PLANNING APPLICATION NO DM/15/03555/VOC

Variation of condition 3 (approved drawings) pursuant to planning permission CMA/4/83 in regard to a revised masterplan that includes landscape and drainage modifications by Banks Group.

On the “Movement Framework” drawing it is clear that people wishing to cycle to the north-west corner of the site, and beyond to Neville’s Cross are well-served. There are three options:

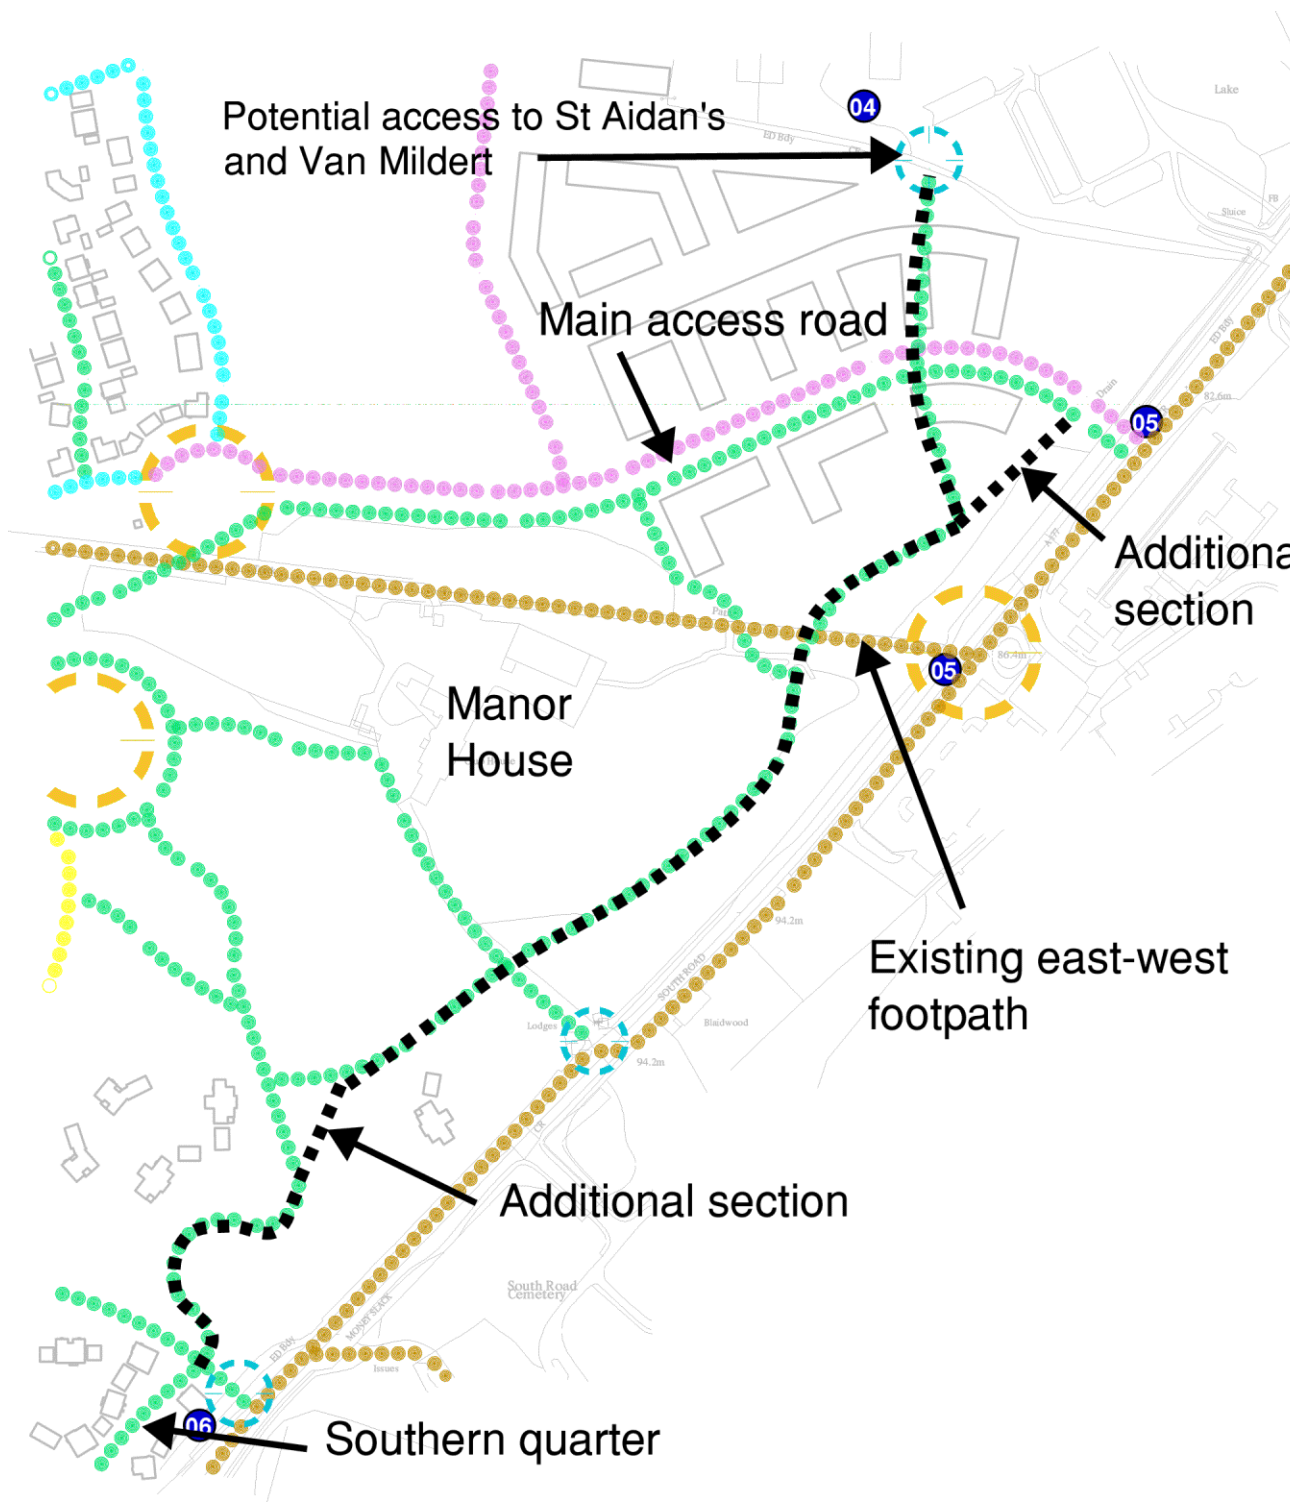
For people wishing to cycle in other directions, the proposed amended masterplan is less satisfactory. Access is required to Elvet Hill Road leading towards Potters Bank for journeys to the city centre via Prebends Bridge. Journeys to the University’s main campus, to St Oswald’s Primary School and to other areas of the city via New Elvet require a route parallel to the A177. It would also make a lot of sense to facilitate cycle journeys from the southern quarter to the proposed convenience store. At present the best option shown is circuitous, involving the informal cycle route (not suitable after dark) or the lightly-trafficked streets, and then the main northern access road emerging near the Park & Ride.

Given that the previous masterplan had designated the route past the manor house as a main cycle and pedestrian route, I request that this aspect of the previous plan be retained, so that good quality cycle routes parallel to both the A167 and the A177 are provided. I suggest that an additional link be provided to give more direct access to the A177 by linking to the access road for the northern quarter.

The path shown overlaid with a black dashed line should be retained as a cycle route as in the previous masterplan, with a couple of modifications to give a more direct route (where the black dashed line is not on top of the green spots).

However, on the plan labelled “MOVEMENT FRAMEWORK” on the web site and entitled “Masterplan Layer – Movement framework, drawing 07B” the same routes are shown with different labels. The existing footpath crossing the site east to west is merely shown as “Existing footpath”. There is no indication that it is to be upgraded for use by cycles. The path linking the southern quarter to the north-west corner of the site is shown with three different indications along its length. The southern section, reaching as far as the existing east-west footpath is shown in yellow, meaning an “informal cycle route” (unlit and unadopted). The next section, reaching two-thirds of the way to the boundary, is shown as “new footpath” with no mention of use by cyclists. The final section is shown in pink, meaning “segregated cycle path”. This corresponds to the section shown in orange on the “Highways & Adopted Roads” plan which is described as “adopted footpaths”. It appears this signifies that this section is lit.

It is unclear what status each of the documents has, but I hope that in accordance with the “Movement Framework” plan the path would continue through to the northern quarter and the point labelled (4) which indicates “connection to St Aidan’s College and Van Mildert College subject to University”.
